**NUMBER:** 09-011-15

Incorrect 6.4L Engine Oil Dipstick

2015 (WK) Jeep Grand Cherokee

Fig. 1 Location Of The Part Number On The Dipstick

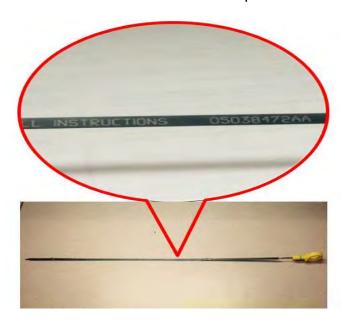
1. Remove the Dipstick from the tube and look for the part number.

- 2. Is part number 05038472AA on the Dipstick?
  - a. Yes >>> Replace the Dipstick with part number 05038472**AB**.
  - b. No >>> This bulletin does not pertain, perform normal diagnostics if needed.
